**TITLE: 2019 ~ 2022 W800 & W800 CAFE HORN REPLACEMENT**

## RECALL

### IMPORTANT SAFETY RECALL NHTSA RECALL NO. 22V-122

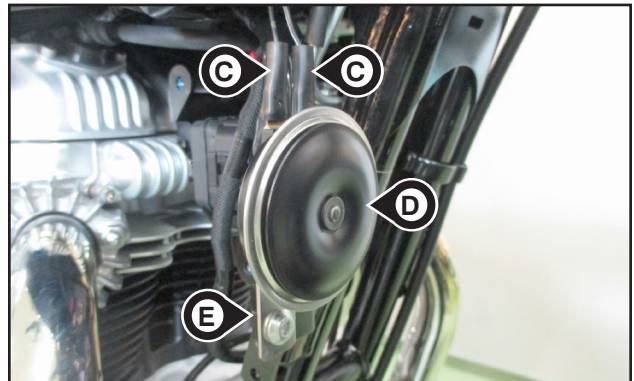
- Disconnect both horn connectors [C].
- Remove Horn [D].
- Remove Bracket [E].

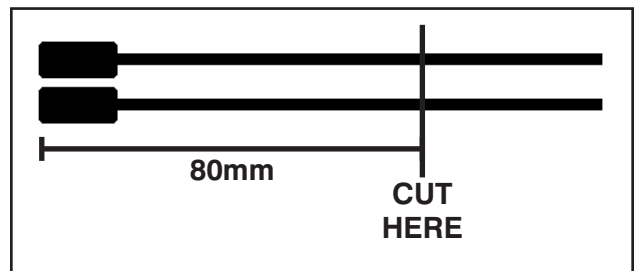
- Cut each lead wire 80mm from the end of the lead connector.

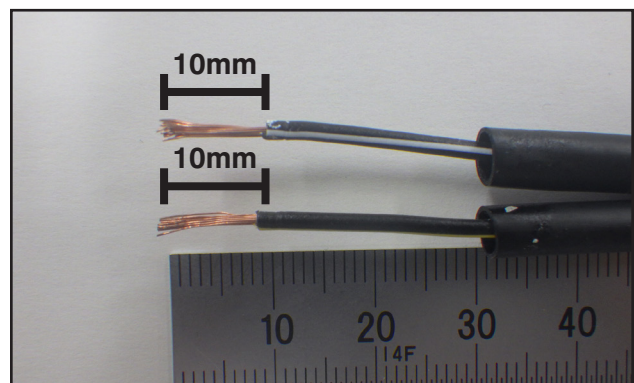
- Strip 10mm of insulation from the ends of both wires making sure that both wires are the same length when done.

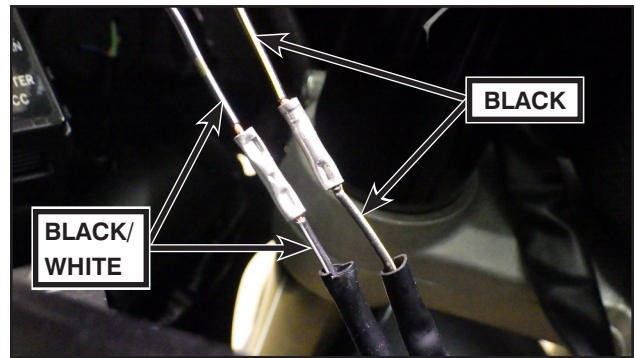
- Match black and black/white wires of the main and repair harness
- Fully insert the stripped ends of the main harness into the butt connectors of the repair harness.

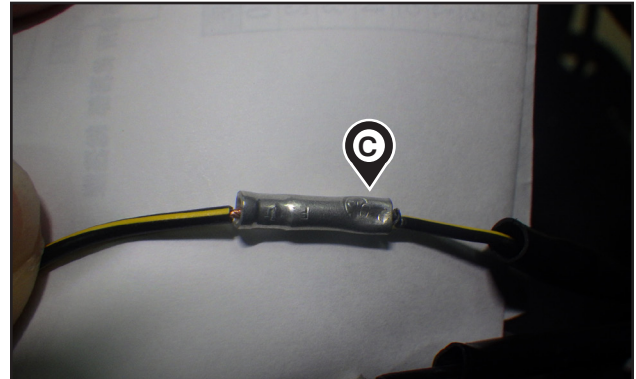
- Crimp [C] both butt connectors firmly.

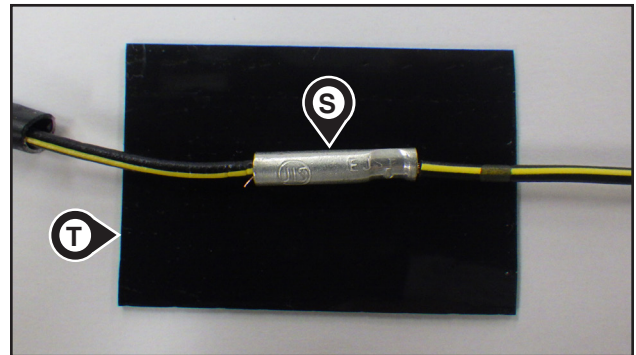
- Position one butt splice [S] on the center of one piece of tape [T] from the repair kit and fold the tape over onto itself.
- Repeat for the other connector.

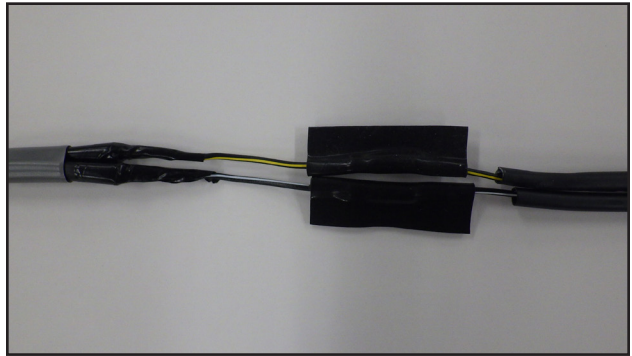
- Wrap the entire repair with 2 layers of plastic tape from the repair kit.

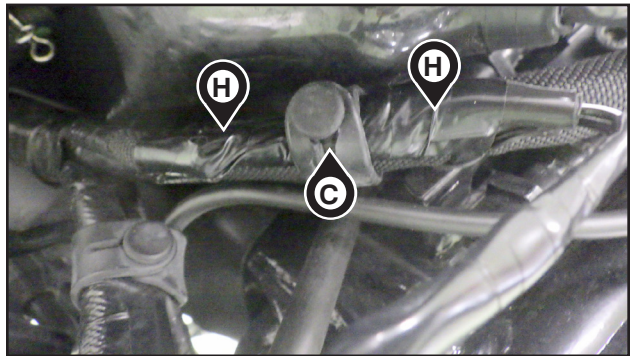
- Route the harness [H] as shown so the clamp [C] is in the center of the repair.

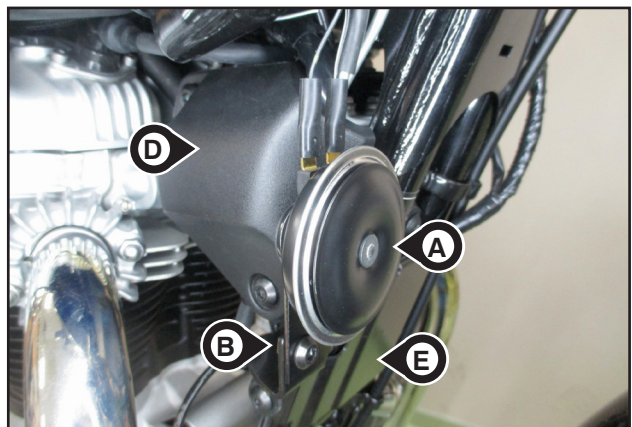
- Install new horn [A] and bracket [B].
- Install covers [D] and [E].
- Install left side of upper inner fairing.
- Connect negative battery terminal.
- Install the ECU.
- Test the horn.
- Install the seat.
